AGENDA
CITY PLANNING COMMISSION

City Hall - Council Chambers
6131 Taylorsville Road
September 9, 2025
6:00 P.M.

To: Huber Heights City Planning Commission
From: Aaron K. Sorrell, Assistant City Manager
Date: September 4, 2025
Subject: FP 25-22 Canal Heights Section 1
(Application dated August 22, 2025)

To: Huber Heights City Planning Commission
From: Aaron K. Sorrell, City Planner
Date: September 4, 2025
Subject: MC 25-18 ABC Supply – Minor Change
4695 Chambersburg Road

REVISIONS:	
REVISION 1 - 6/26/2025	
REVISION 2 - 7/3/2025	
REVISION 3 - 8/8/2025	
REGIONAL APPROVAL DATE:	
ISSUE DATE:	
7/27/2023	
DRAWN BY:	
SPENCER BEYTEN	
SHEET:	
ENLARGED PROPOSED SITE PLAN	
C100

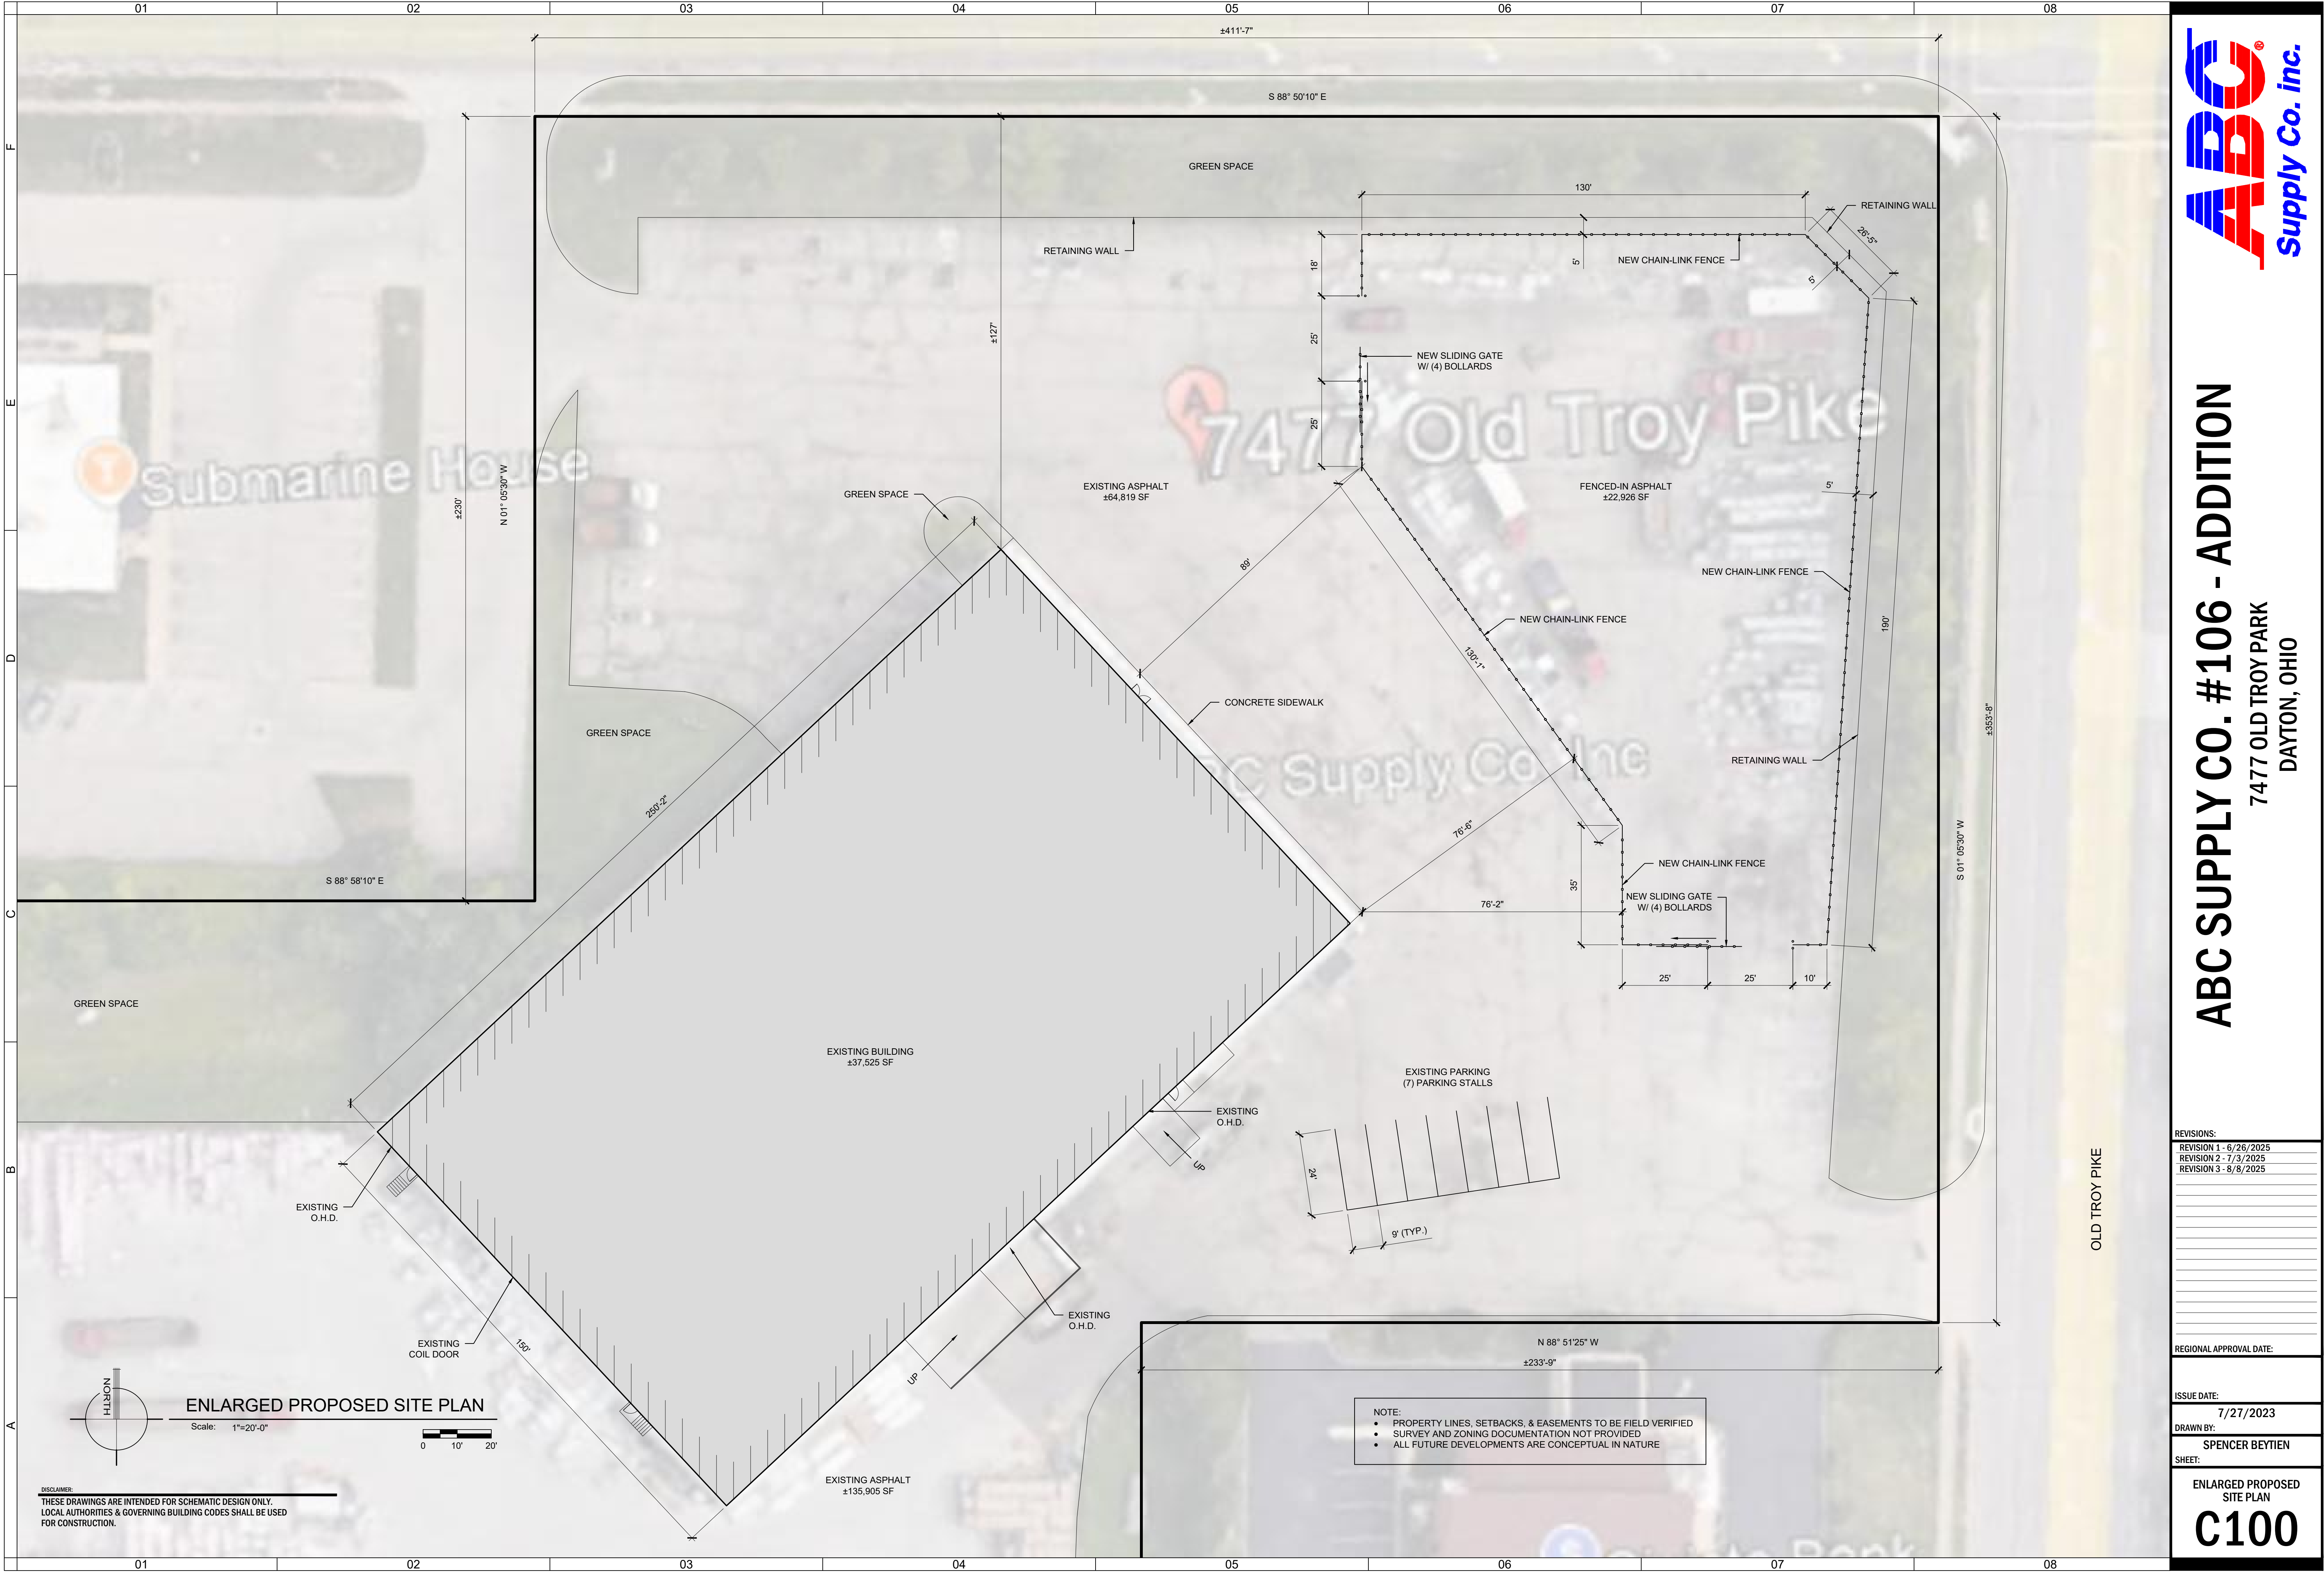
Impact on the public right of way: The proposed location has a substantial grade differential between the public right of way, ranging from eight (8) feet to 14 feet below the road and sidewalk grade. The most significant visual impact will likely be from eastbound Taylorsville Road, where the fenced-in area will be more visible. While there is an impact, staff believe this impact can be mitigated should a change in fencing material and additional tree plantings.

Fire: The Fire Department requests that two parking stalls on the south side be removed to widen the travel lane between the proposed fencing. This request has been communicated to the applicant.

1. There shall be no outdoor storage or sales of materials or inventory. The fenced areas shall be limited in use to delivery staging and vehicle parking.
2. Fencing material shall be black color-coated
3. The applicant shall plant additional evergreen trees and replace existing diseased or dying evergreen trees, at least 15 feet behind the sidewalk, to fill missing gaps in the existing vegetation.
4. The applicant will comply with Fire Department requirements.
5. The applicant will submit a revised site plan with their zoning permit application that complies with the Planning Commission Decision Order.
